Parent Item Name: Crosstube Turning Detail

DRAWING NO. D407-667-145	TITLE CROSSTUBE ASS'Y (407 HIGH FWD)	REV. C	DART AEROSPACE LTD ENGINEERING ORDER		D.E.O. NO. D407-667-145-C-1	SHEET NO. SHEET 1 OF 1	SCALE NTS
DRAWN <i>Q</i>	CHECKED <i>ASS</i>	MFG. APPR. <i>AB</i>	APPROVED <i>WD</i>		DE APPR. <i>W</i>		
DATE 11.07.15	DATE 11.07.22	DATE 11.07.22	DATE 11/07/22		DATE 11.07.21

REPLACE MAGNOBOND WITH PROSEAL.

ADD ELECTRICAL GROUNDING STRAP

DETAIL P
BONDING STRAP INSTALLATION 2 PL

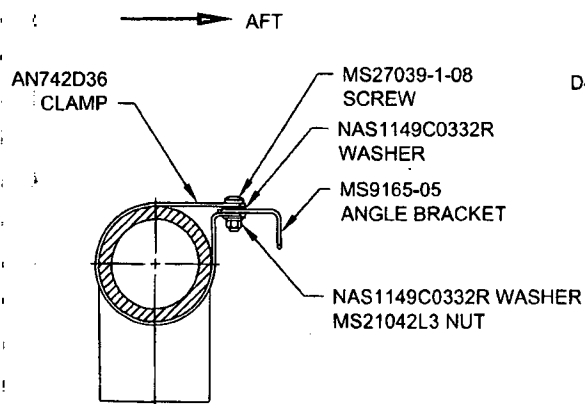
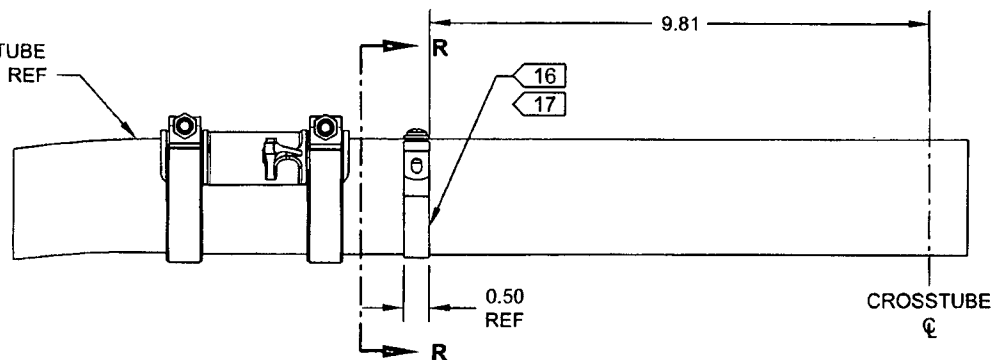
ITEM	QTY -145	PART NUMBER	DESCRIPTION
1	X	D407-667-145	CROSSTUBE ASSEMBLY (407 HIGH FWD)
10	2	AN742D36	CLAMP
11	2	MS9165-05	ANGLE BRACKET
12	2	MS21042L3	NUT (OR MS21042-3)
13	2	MS27039-1-08	SCREW
14	4	NAS1149C0332R	WASHER (OR AN960C10L)

- 16) MASK AREA UNDER CLAMP PRIOR TO PAINTING
- 17) SEAL EDGES WHERE AN742D36 CLAMP MEETS WITH THE CROSSTUBE USING SIKAFLEX-241/-291 OR MIL-S-8802 CLASS B2 OR PROSEAL 890 SEALANT
- 18) PERFORM RESISTANCE CHECK TO ENSURE MAX RESISTANCE IS 10 MILLIOHMS
